SUPPLEMENTAL BID BULLETIN NO. 01

(PSC-BAC-031-2024)

Project Name	Approved Budget for the Contract (ABC)
Supply and Installation of VIP Room Seats for Chairman's Box and VIP Rooms 2,3,4 and 7 at MPA	PHP 3,688,740.00

that this Supplemental Bid Bulletin is issued to modify in the Philippine Bidding Document:

PHILSPORTS ARENA
PROPOSED VIP ROOM-1 SEATING LAYOUT

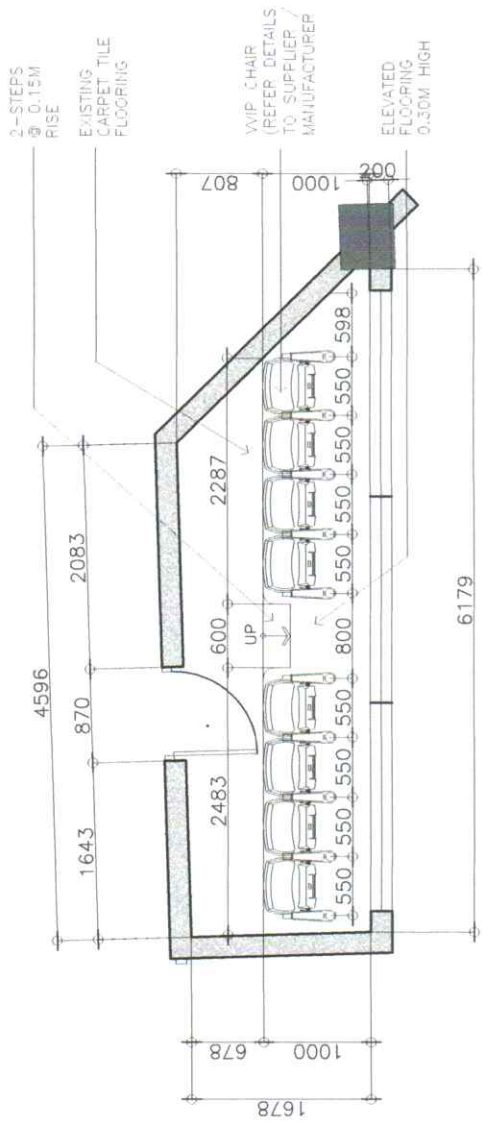
Amendments
From
<p><i>Section VII. Technical Specifications/Terms of Reference</i></p> <p>Item 1: Supply and Installation of Raised Flooring Panel Bare Type</p> <p>Specifications:</p> <ul style="list-style-type: none"> C/C (Arm Center to Center): 550mm Overall Depth with Seat Open: 810mm Overall Depth with Seat Closed: 620mm Inner Seat Depth: 460mm Floor to Seat Height: 445mm Floor to Armrest Height: 625mm Overall Height: 1035mm Color: Red See attached plan/details <p><i>Note: A tolerance of ±10mm (0.4") is allowed for the above dimension.</i></p>
To
<p><i>Section VII. Technical Specifications/Terms of Reference</i></p> <p>Item 1: Supply and Installation of Raised Flooring Panel Bare Type</p> <p>Specifications:</p> <ul style="list-style-type: none"> C/C (Arm Center to Center): 550mm Overall Depth with Seat Open: 810mm Overall Depth with Seat Closed: 620mm Inner Seat Depth: 460mm Floor to Seat Height: 445mm Floor to Armrest Height: 625mm Overall Height: 1035mm Color: Red See attached plan/details (Annex of this SBB) <p><i>Note: A tolerance of ±10mm (0.4") is allowed for the above dimension.</i></p>

RAISED FLOORING DETAILS
SCALE
NTS

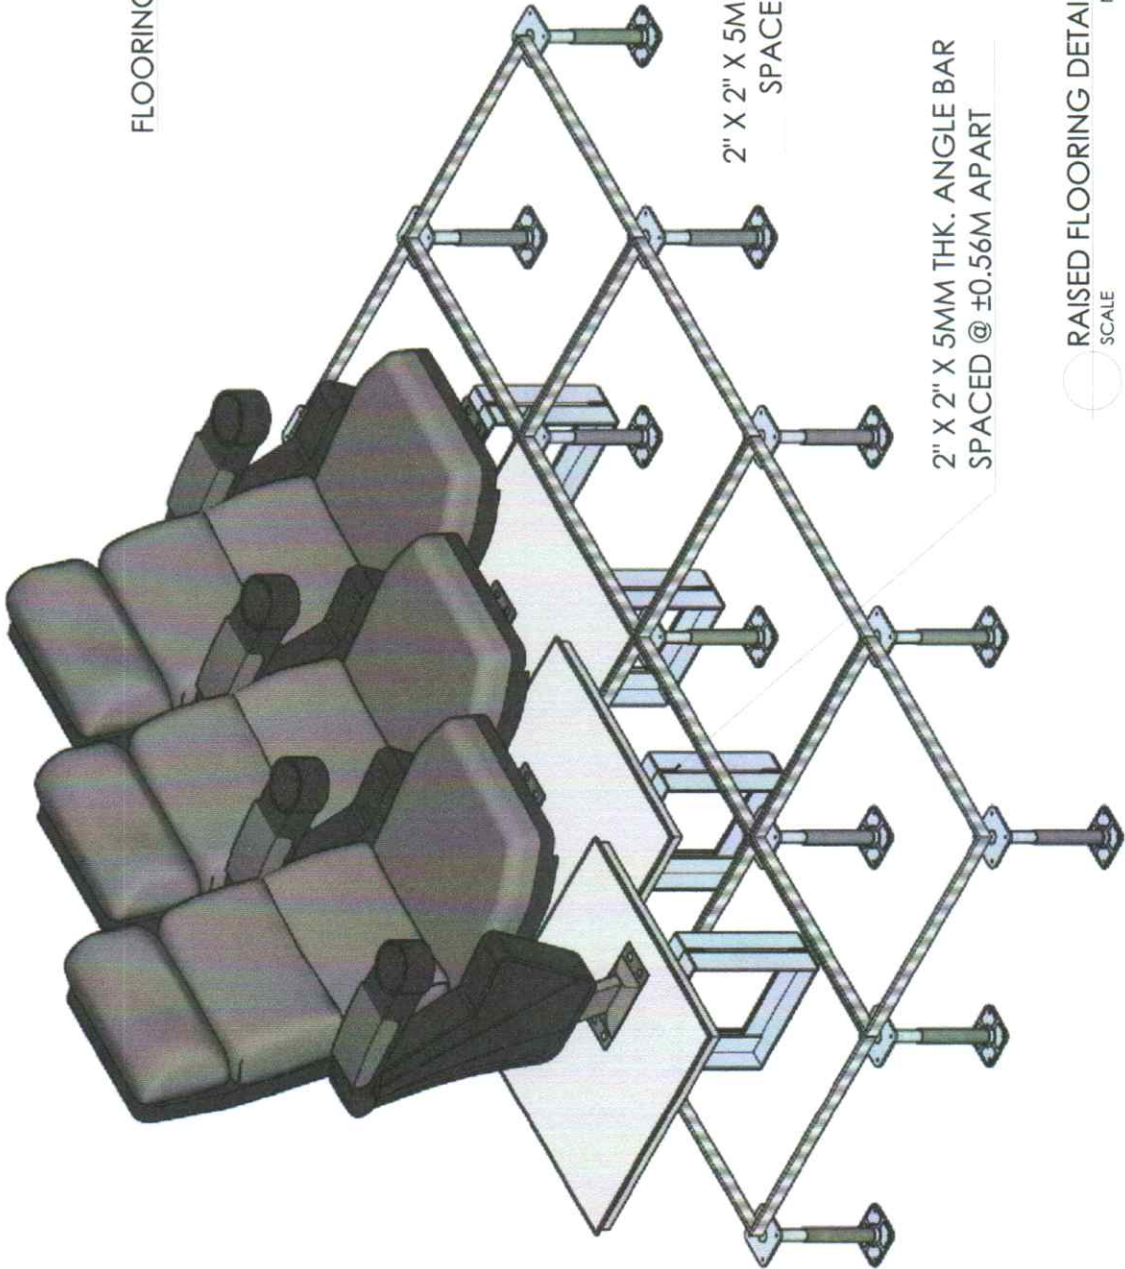
Amendments
From
<p><i>Section VII. Technical Specifications/Terms of Reference</i></p> <p>Item 2: Supply and Installation of Raised Flooring Panel Bare Type - 62m²</p> <p>Specifications:</p> <ul style="list-style-type: none"> 150mm Pedestal Height with Stringer Support – First Row 300mm Pedestal Height with Stringer Support – Second Row Includes 2" x 2" x 5mm Thick Angle Bars See attached plan/details <p>Item 3: Supply and Delivery of Spectator's Seats</p> <p>Specifications:</p> <ul style="list-style-type: none"> Seat Width: 430mm Seat Base Height: 470mm Step Depth: 555mm Color: Black See attached details
To
<p><i>Section VII. Technical Specifications/Terms of Reference</i></p> <p>Item 2: Supply and Installation of Raised Flooring Panel Bare Type - 62m²</p> <p>Specifications:</p> <ul style="list-style-type: none"> 150mm Pedestal Height with Stringer Support – First Row 300mm Pedestal Height with Stringer Support – Second Row Includes 2" x 2" x 5mm Thick Angle Bars See attached plan/details (Annex of this SBB)

2" X 2" X 5MM THK. ANGLE BAR
SPACED @ ±0.56M APART

2" X 2" X 5MM THK. ANGLE BAR
SPACED @ ±0.56M APART

SPECTATOR'S SEATS

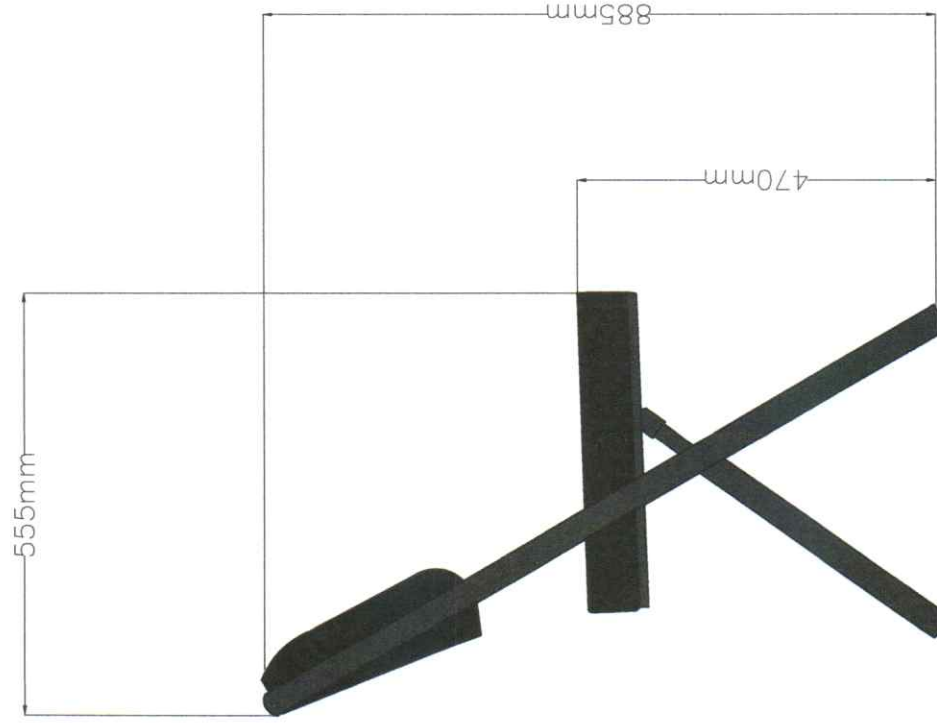
Item 3: Supply and Delivery of Spectator's Seats

- Seat Width: 430mm
- Seat Base Height: 470mm
- Step Depth: 555mm
- Color: Black
- See attached details (Annex of this SBB)
